01 SITE PLAN
1" = 50'-0"

DISD - W.W. BUSHMAN REPLACEMENT ELEMENTARY SCHOOL

ZONING CASE # Z 212-271

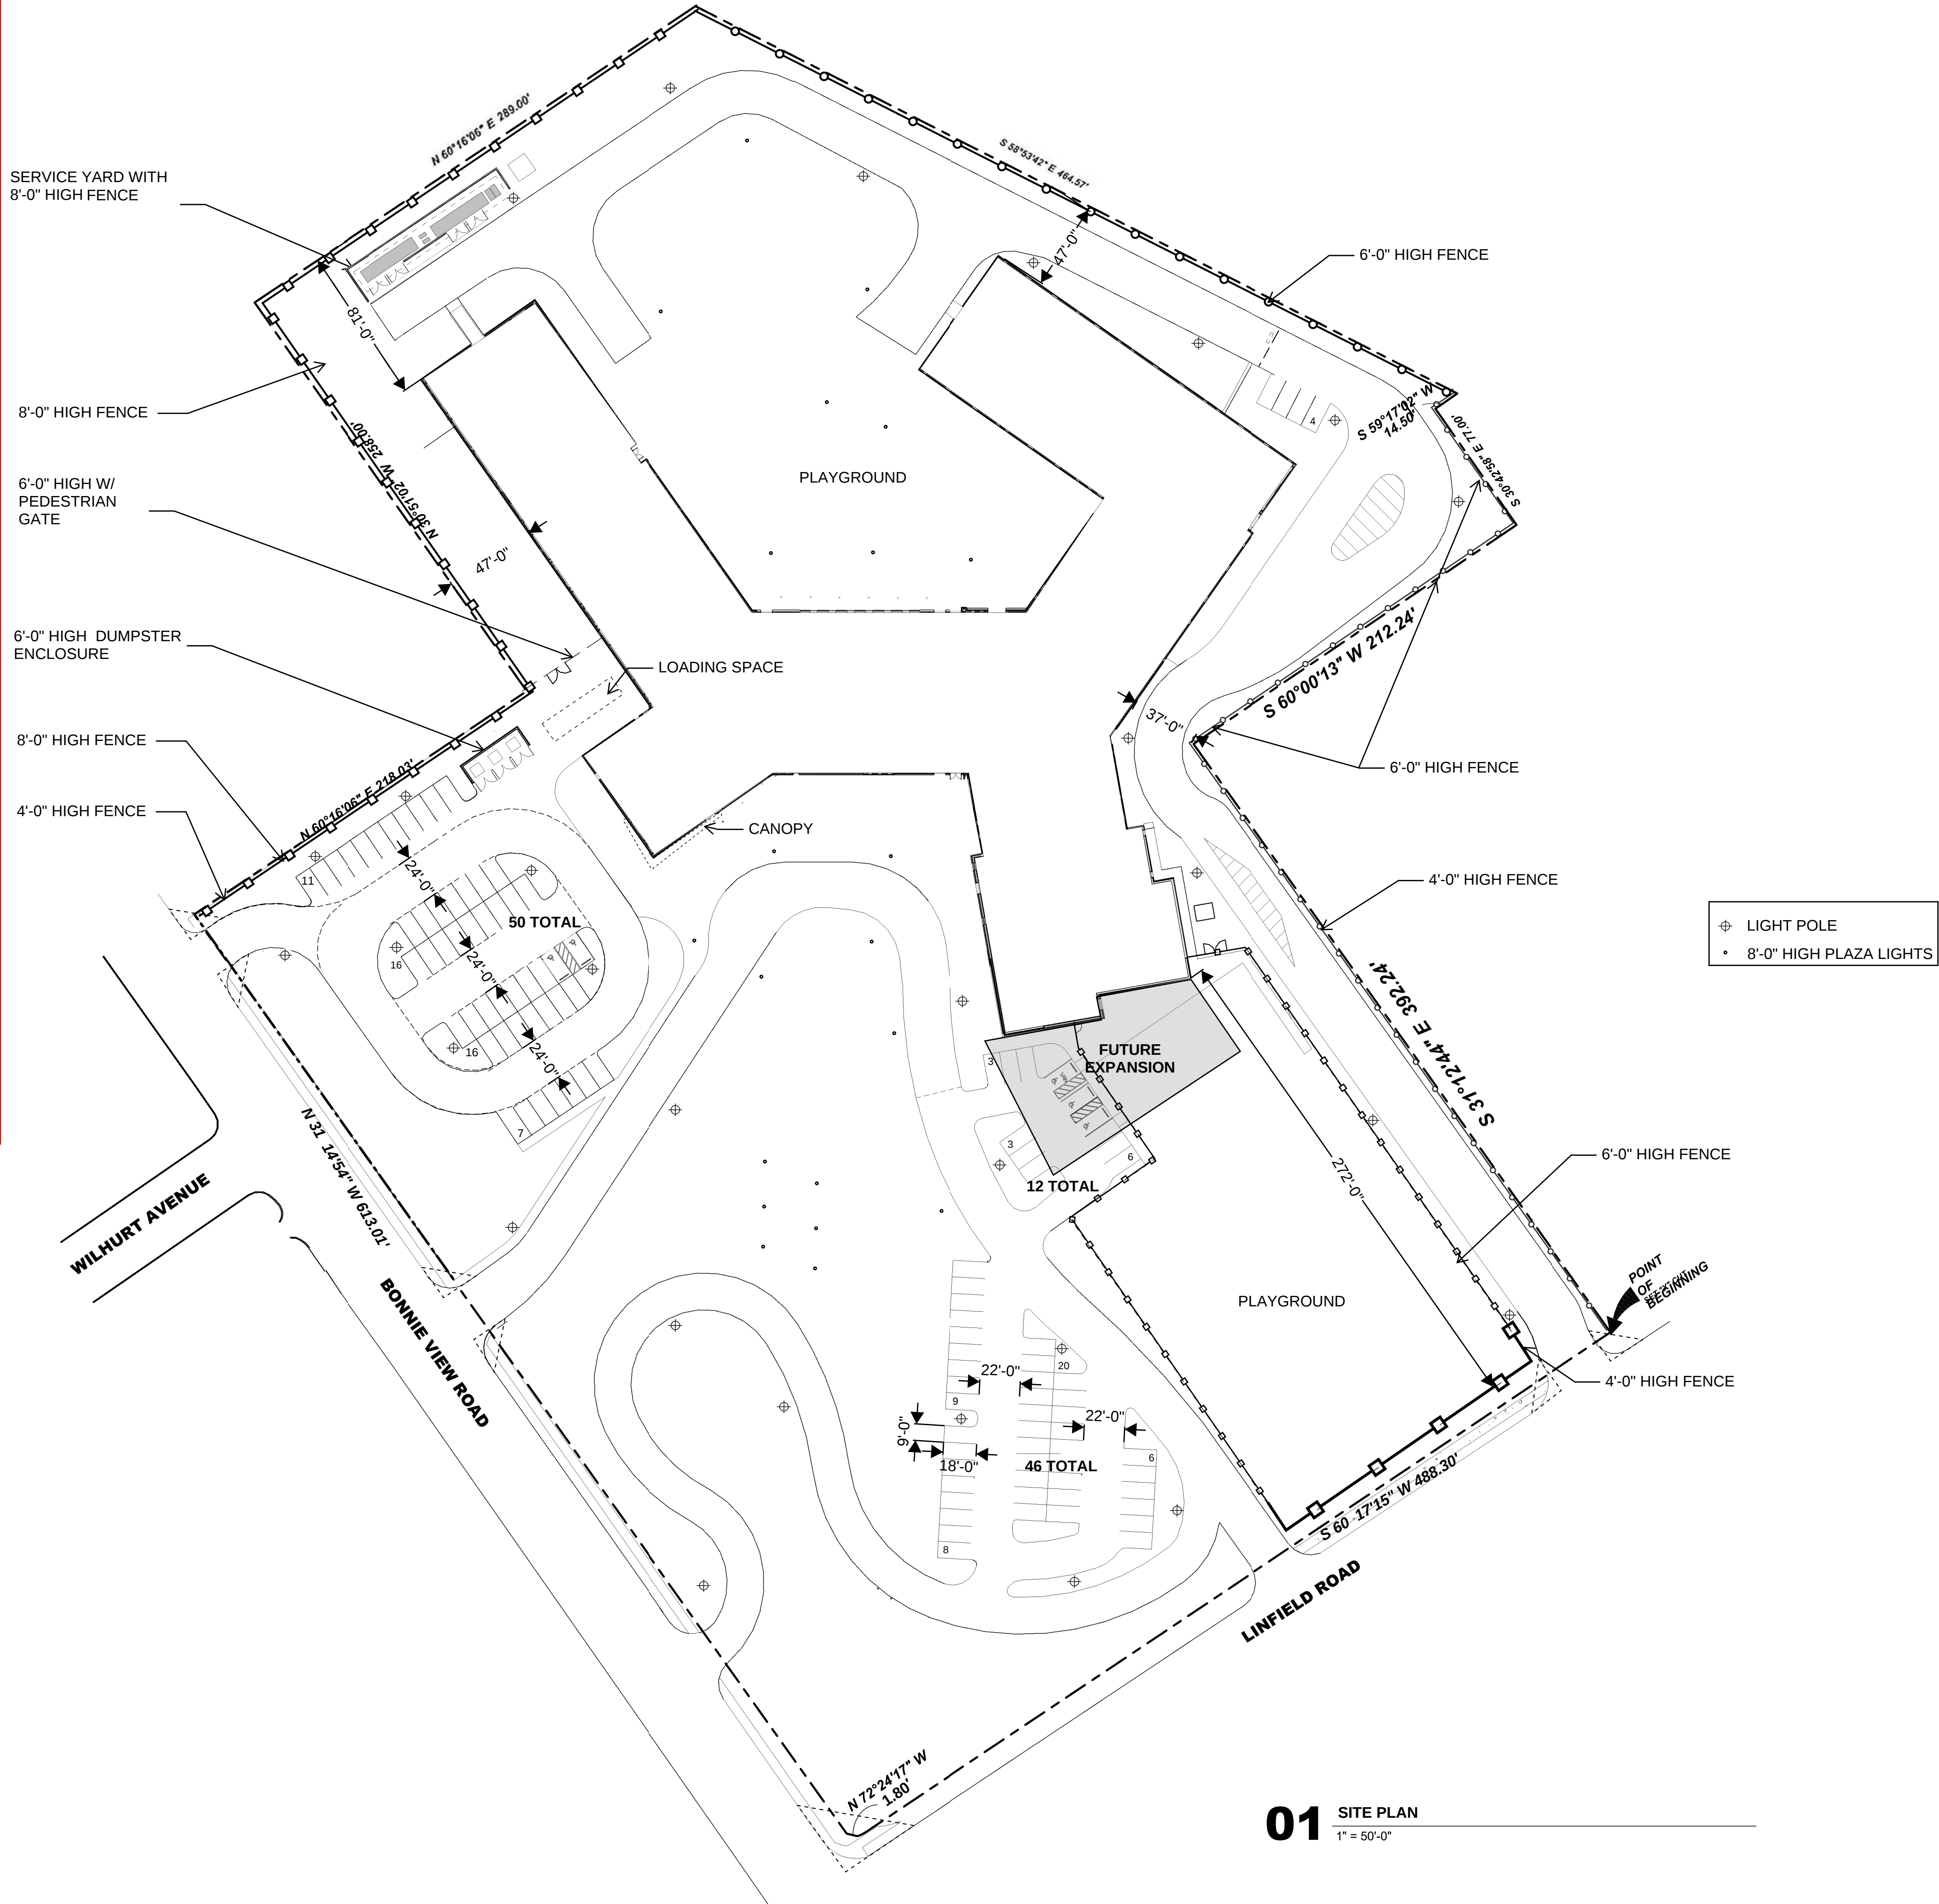
Staff comments:

1. ADD THE FOLLOWING TO THE DATA TABLE:
-> NUMBER OF LOADING SPACES REQUIRED
-> PARKING RATIO
-> NOTE INDICATING LOCATION OF BICYCLE PARKING SPACES TO BE DETERMINED AT PERMITTING.

2. TABLE HAS INCORRECT DATA.
-> CONFIRM THE MATH AND CORRECT THE DATA.
3. SHOW SIDEWALK/BUFFER FULL LENGTH OF ALL STREET FRONTAGES AND ADD NOTE:
"MINIMUM 6'-0" WIDE SIDEWALK w/ MINIMUM 5'-0" WIDE BUFFER MUST BE PROVIDED ALONG THE ENTIRE LENGTH OF ALL STREET FRONTAGES, TYP."

- "NOTE: 5'-0" WIDE SIDEWALK IS MINIMUM REQUIRED FOR ADA COMPLIANCE; HOWEVER, STAFF RECOMMENDS MINIMUM 6'-0" WIDE SIDEWALKS AT SCHOOLS. OTHER PEDESTRIAN AMENITIES SUCH AS BENCHES, TRASH CANS, AND PEDESTRIAN SCALE LIGHTING ARE RECOMMENDED AT REGULAR INTERVALS ALONG STREET FRONTAGES, HOWEVER, THESE ITEMS ARE NOT CURRENTLY REQUIRED BY CODE.

4. SHOW VISIBILITY TRIANGLES AT ALL POINTS OF INGRESS/EGRESS, AND REVISE PLAN TO REMOVE VISIBILITY OBSTRUCTIONS.
5. EXTEND THROAT OF DRIVEWAY ON LINFIELD TO AVOID ABRUPT TURN SINCE DESIGN DOES NOT PHYSICALLY DISCOURAGE WRONG WAY TURNS.
-> TMP DOES NOT SHOW THIS DRIVEWAY AS ONE-WAY OPERATIONS. NOT APPROVABLE AT PERMITTING AS CURRENTLY PROPOSED.

6. ADD PAVED PEDESTRIAN PATH ALONG CIRCUITOUS DRIVEWAYS AND/OR PEDESTRIAN ROUTES THROUGH THE CAMPUS FROM ALL ACCESS POINTS.
-> TMP DOES NOT SHOW ANY PEDESTRIAN RESTRICTIONS. AS CURRENTLY PROPOSED, THE DESIGN WILL NOT DISCOURAGE ACCESS TO PEDESTRIANS BUT WILL CREATE UNSAFE CONDITIONS FOR STUDENTS INSTEAD. NOT APPROVABLE AT PERMITTING AS CURRENTLY PROPOSED.

7. REVISE INTERNAL CONNECTION w/PERPENDICULAR INTERSECTION PER ENGINEERING/TRAFFIC STAFF COMMENTS.
-> SEE STAFF COMMENTS UNDER NOTE 6 ABOVE.
8. ENSURE THAT SITE PLAN AND TMP ARE CONSISTENT BEFORE SUBMITTING REVISIONS.

9. BECAUSE THE PROPERTY HAS AN APPROVED PRELIMINARY PLAT WHICH WILL BE RELIED UPON TO ESTABLISH A BUILDING SITE FOR CONSTRUCTION OF THE REPLACEMENT SCHOOL, PROPERTY LINES MUST BE SHOWN PER THE APPROVED PRELIMINARY PLAT, ADJUSTED PER CPC APPROVAL CONDITIONS.
-> SITE PLAN IS NOT APPROVABLE AS SHOWN. REVISION REQUIRED.
-> ADJUST PROPERTY LINE LOCATIONS AND DIMENSIONS PER CPC APPROVAL CONDITIONS 15 & 16 IF DEDICATIONS WILL BE FEE SIMPLE.
-> IF DEDICATIONS WILL BE VIA STREET EASEMENT, SHOW STREET EASEMENT LINES.
-> ENSURE THAT PROPOSED DESIGN MEETS SETBACK REQUIREMENTS TAKEN FROM NEW PROPERTY LINES OR FROM STREET EASEMENT LINES, AS APPLICABLE.
